**Minor/Minor Site Review for New Detached Single Family Dwelling,
All Purpose Building Permit Application**

BUILDING PERMIT REPORT

REASON FOR PERMIT: 12' x 12' Two story addition.

Virginia St Front

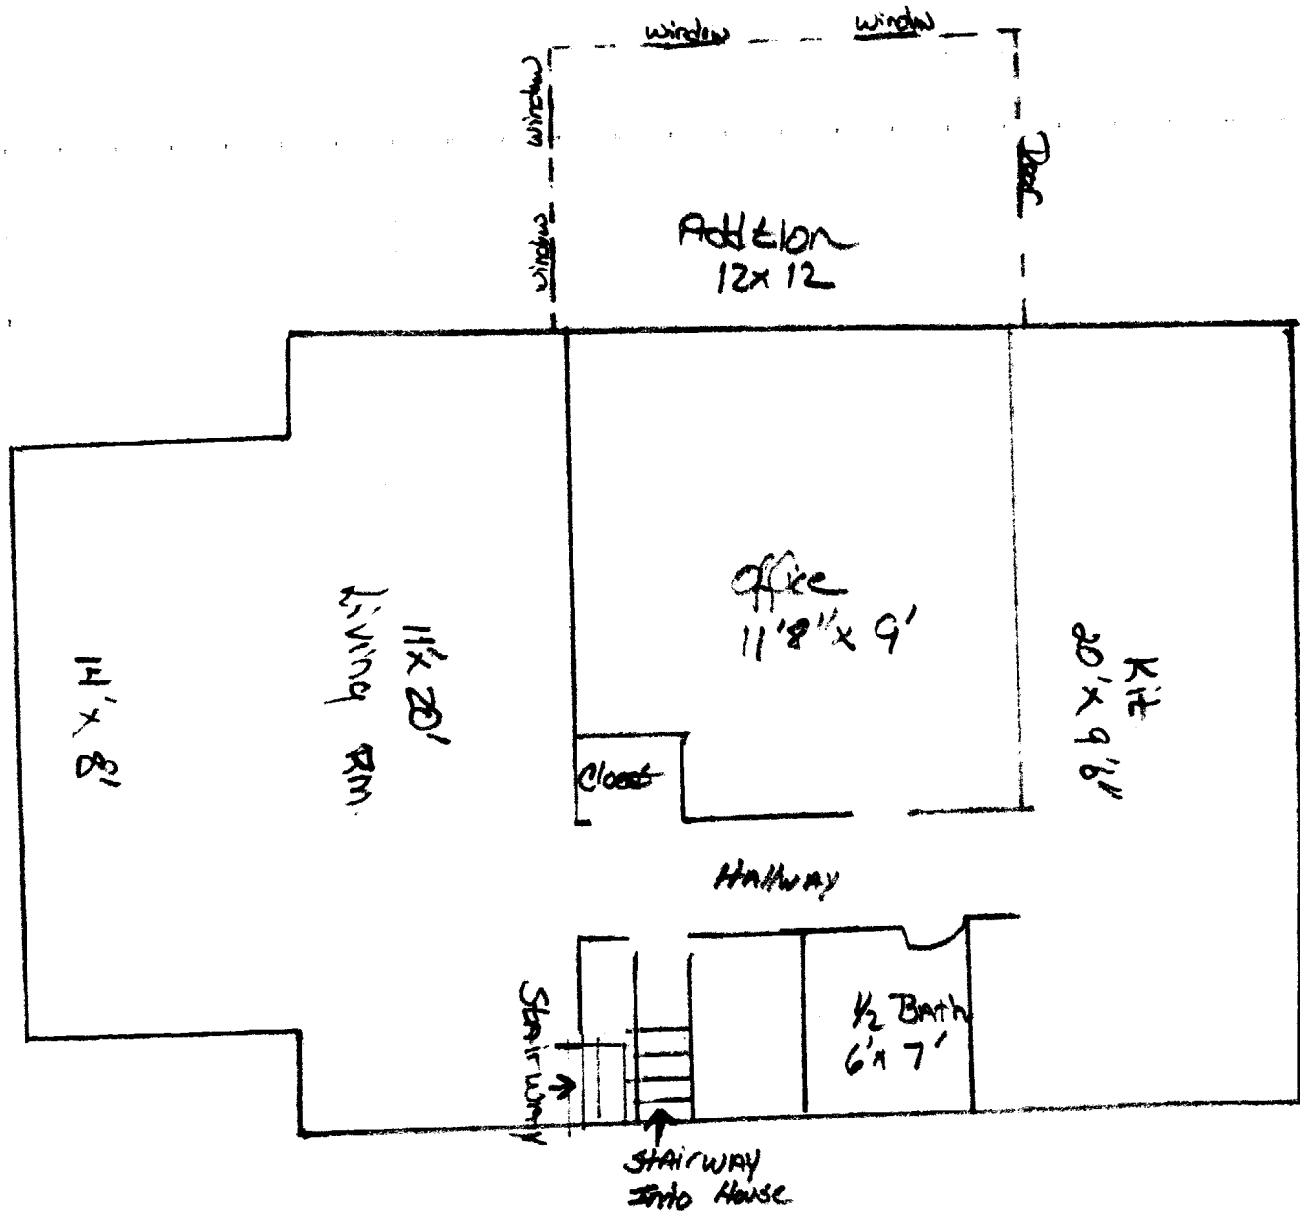
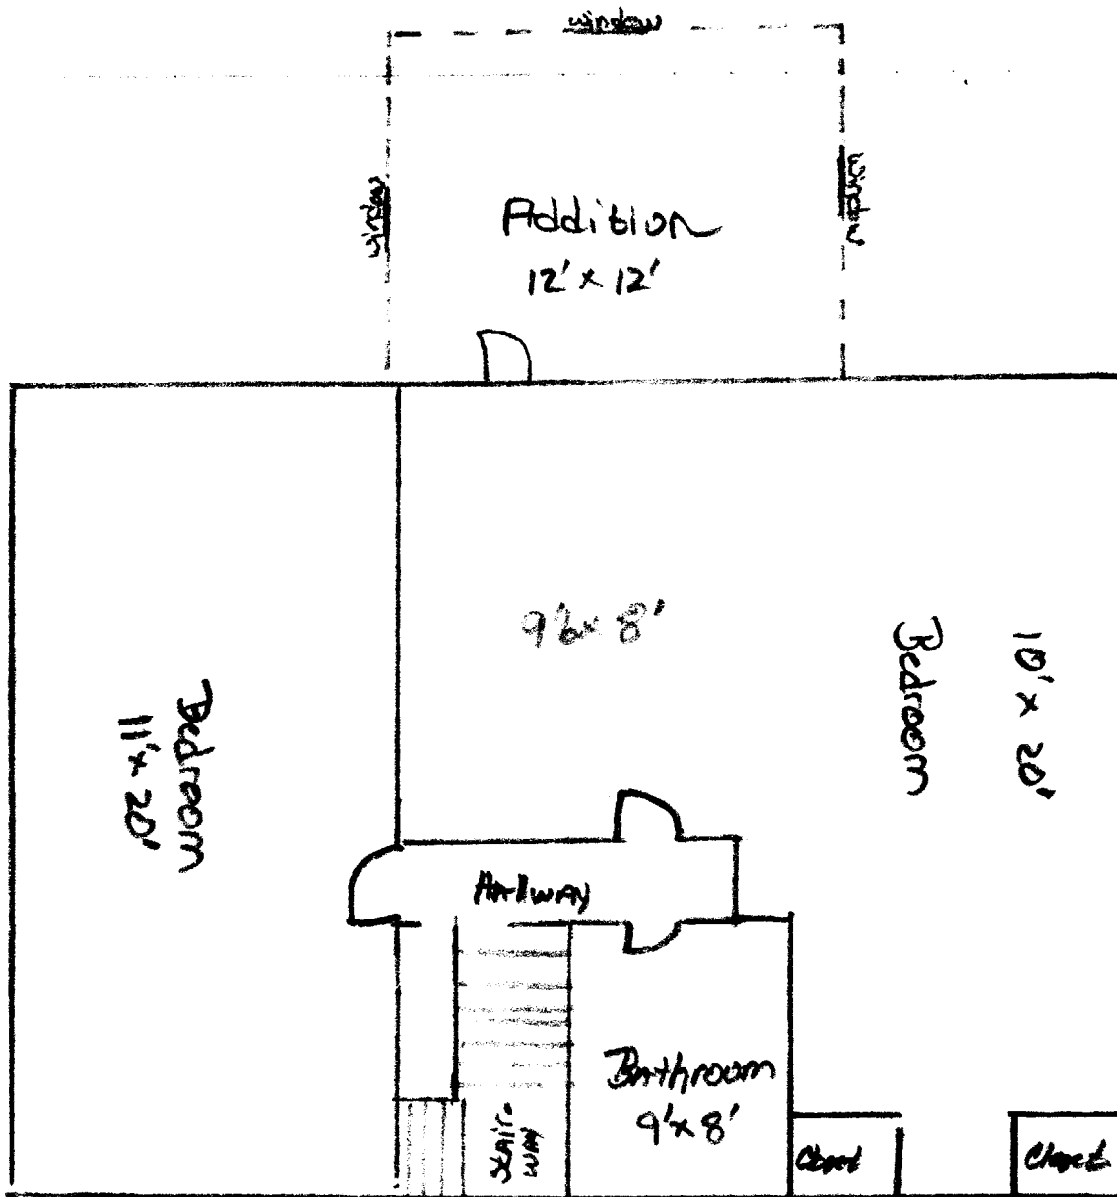
R-3 Zone
 using Section 14-433 for side yard reduction
 OK

front: 25' req - 25' + show
 rear: 25' req - 35' + show
 side yard: 20' req - 13' show

Flashing
1406.3.10

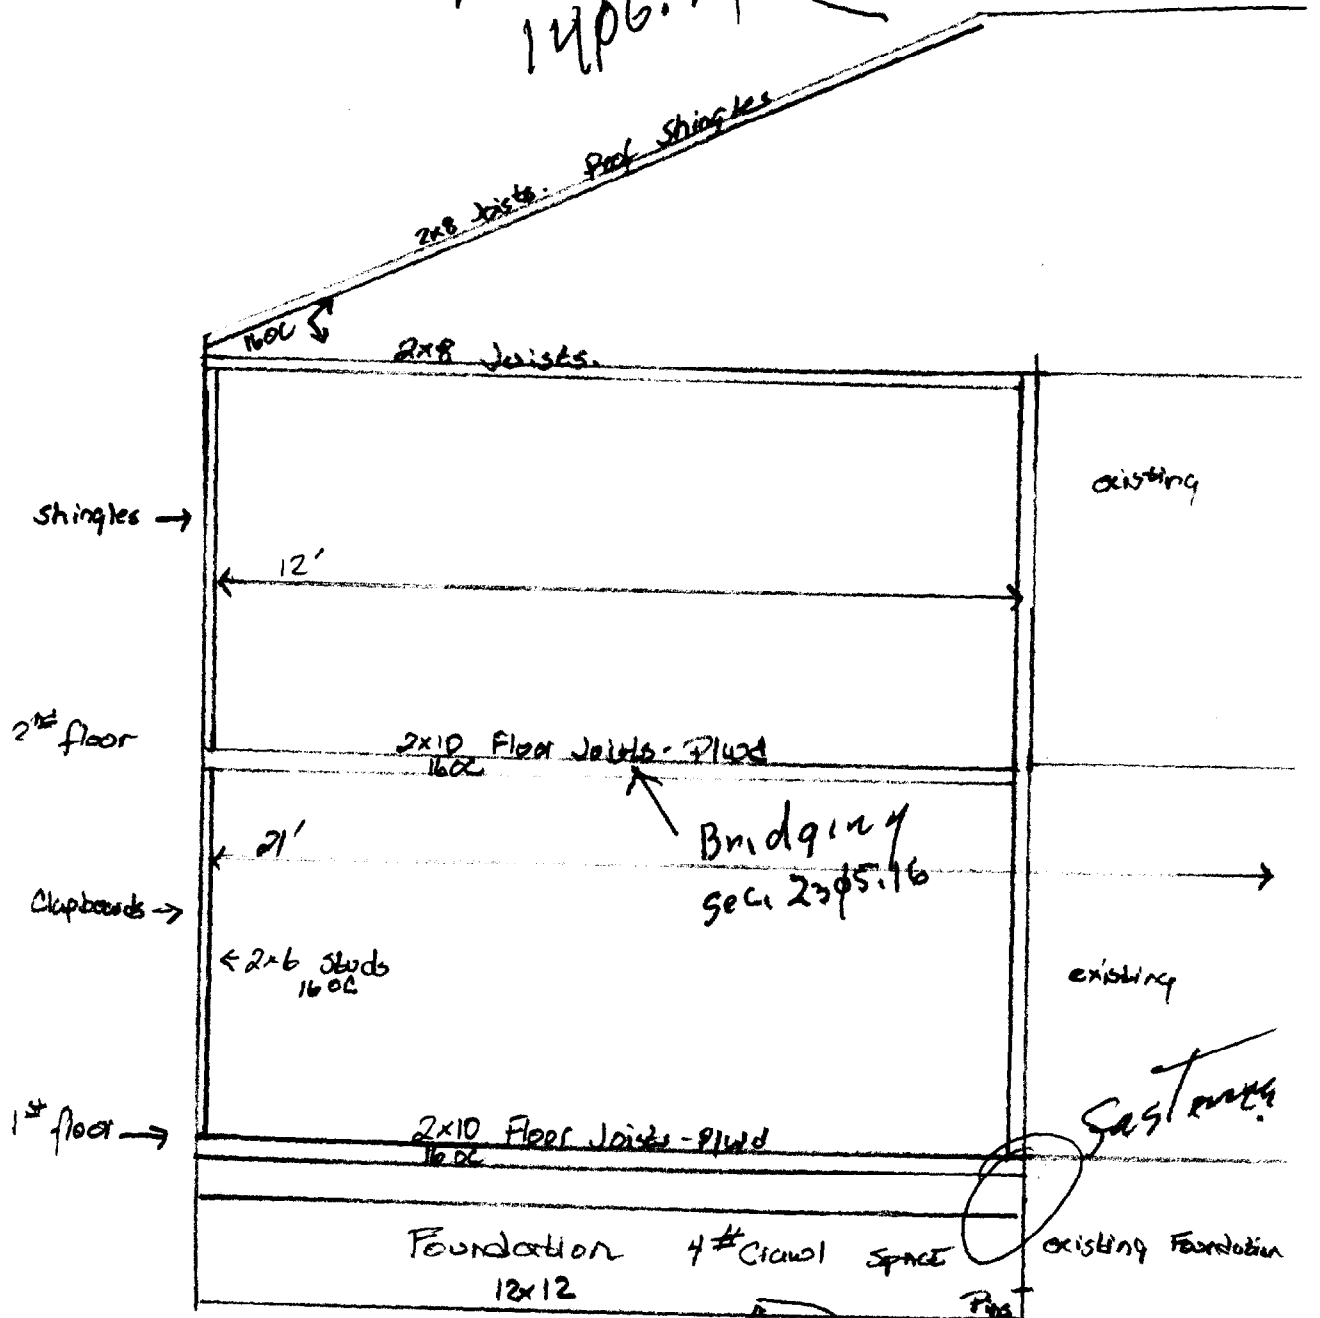
Ventilation
sec. 1210.0
1211.0
